CITY PLAN COMMISSION

FILE NUMBER: S234-066

REQUEST: An application to create one 2.0631-acre lot from a tract of land in City Block 8524 on property located on Dowdy Ferry Road, north of Lyndon B Johnson Freeway/ Interstate Highway No. 20.

PRELIMINARY PLAT
 QT STORE NO. 1893 ADDITION
 LOT 1, BLOCK 8524
 CITY BLOCK NO. 8524
 BEING A 2.0631 ACRE TRACT OF LAND
 JOHN R. FOUNDER SURVEY ABSTRACT NO. 476
 CITY OF DALLAS, DALLAS COUNTY, TEXAS
 CITY PLAN FILE NO. 5234-966

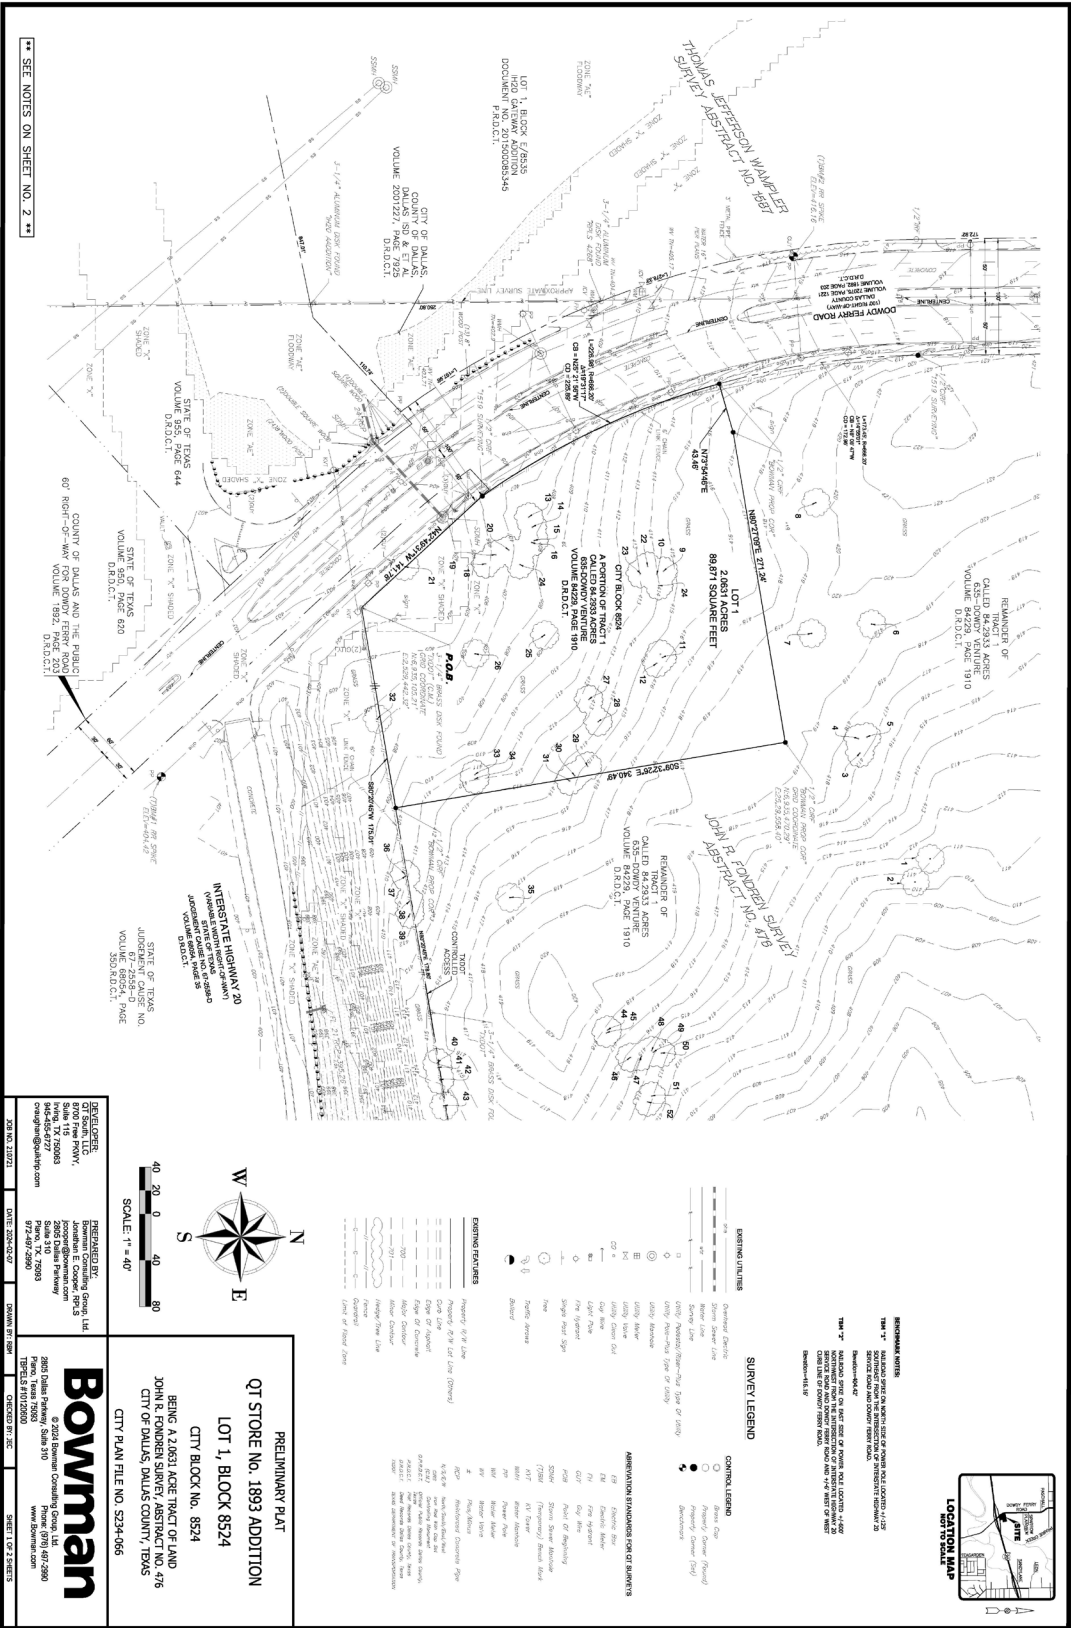
1. The final plat must conform to all requirements of the Dallas Development Code, Texas Local Government Code, Texas Land Surveying Practices Act and the General Rules and Regulations of the Texas Board of Land Surveying.

2. Department of Development Services, Engineering Division must verify that the plat conforms with the water, wastewater, and easement requirements under the provisions of Chapter 49 of the Dallas City Code.

3. Compliance with all plans, contracts, ordinances, and requirements of the City of Dallas. *Section 51A-8.102(a), (b), (c), and (d)*
4. The number and location of fire hydrants must comply with the Dallas Fire Code.

5. Any new or existing structure may not extend across new property lines. *Section 51A-8.503(e)*
6. On the final plat, all easement abandonments, and ROW abandonments must be by separate instrument with the recording information shown on the face of the plat. A release from the Real Estate Division is required prior to the plat being submitted to the Chairman for signature.

7. On the final plat, include two boundary corners tagged with these coordinates: "Texas State Plane Coordinate System, North Central Zone, North American Datum of 1983 on Grid Coordinate values, No Scale and no Projection."

8. On the final plat, monument all set corners per the Monumentation Ordinance. Prior to submittal of the final plat for the Chairman's signature. The monuments must be verified by the Chief City Surveyors Office in the Public Works Department. *Section 51A-8.617*

9. Provide ALL supporting documentation (i.e. deeds, plats, ordinances, easements...etc) with a completed Final Plat Checklist to the Survey Plat Review Group (**SPRG**) with the Final Plat Submittal **after** City Plan Commission Approval.

10. Prior to the final plat, submit a tree survey to the Arborist. A release from the arborist is required prior to an early release request or the recordation of the plat, whichever occurs first.

11. The number of lots permitted by this plat is one.

12. Submit a full set of Civil Engineering Plans (drainage, paving, street signage/markings/lighting) prepared per City Standards by a licensed (TX) Professional Engineer to Engineering Division in Room 200, Oak Cliff Municipal Center (i.e. 311T/DP). Additions and alterations to the public infrastructure require approval and may require private development contracts with bonds. 51A-8.102 (c); 8.601(b)(4),(5),(6),(7),(8),(9)
13. Detention may be required if the capacity of available outfall is not adequate to carry the developed runoff. Section 51A-8.611(c).
14. Place a note on the final plat stating "Lot-to-Lot drainage will not be allowed without proper City of Dallas Engineering Division approval" 51A 8.611(e)

15. On the final plat, dedicate 50 feet of right-of-way (via fee simple) from the established center line of Dowdy Ferry Road. *Section 51A 8.602(c)*
16. TxDOT approval may be required for any driveway modification or new access point(s).
17. Must coordinate with Transportation Department for any traffic signal requirements that are deemed necessary for improving pedestrian accessibility and safety related to site development. (Contact Srinivasa Veeramallu with Traffic Signals) Section 51A-8.606, 51A-8.608

18. On the final plat, determine the 100-year water surface elevation across this addition.
19. On the final plat, dedicate floodway easement, floodway management area or floodway easement (within common area), with the appropriate easement

statement included on the face of the Plat. 51A 8.611(d); DWU Floodplain Management; Drainage Design Manual Addendum V

20. On the final plat, include additional paragraph in Owner's Certificate (pertaining to the floodplain). 51A 8.611(d); DWU Floodplain Management; Drainage Design Manual Addendum V
21. On the final plat, specify minimum fill and minimum finished floor elevations. *Section 51A-8.611(d), Trinity Watershed Management.*
22. On the final plat, show the natural channel set back from the crest of the natural channel. *Section 51A-8.611(d), Trinity Watershed Management.*
23. Prior to submission of the final plat, set floodway monument markers and provide documentation that the monuments have been set. *Section 51A-8.617(d)(1), (2), (3), and (4)*
24. Provide information regarding Fill Permit or Floodplain Alteration Permit if such permit is applied for.

25. Prior to final plat, submit a completed final plat checklist and all supporting documents.
26. On the final plat, show the correct recording information for the subject property.
27. On the final plat, show recording information on all existing easements within 150 feet of the property.
28. On the final plat, show all additions or tracts of land within 150 feet of the property with recording information.

29. Additional design information is required for assessment. Site plan must be submitted showing proposed development, building finished floor elevation, development, existing mains – including downstream manhole, and proposed water and wastewater service locations. Submit water/wastewater engineering plans to 320 E. Jefferson Blvd., Room 200, Attention: Water and Wastewater Engineering.
30. Engineer must furnish plans for water and sanitary sewer. Developer must furnish a contract for water and sanitary sewer. Sections 49-60(g)(1) and (2) and 49-62(b), (c), and (f).
31. Wastewater main improvements may be required by Private Development Contract. Submit water/wastewater Engineering Plans to 320 E. Jefferson Blvd., Room 200, Attention: Water and Wastewater Engineering.

32. On the final plat, change "Interstate Highway 20" to "Lyndon B Johnson Freeway/ Interstate Highway No. 20".
33. On the final plat, identify the property as Lot 1 in City Block A/8524.
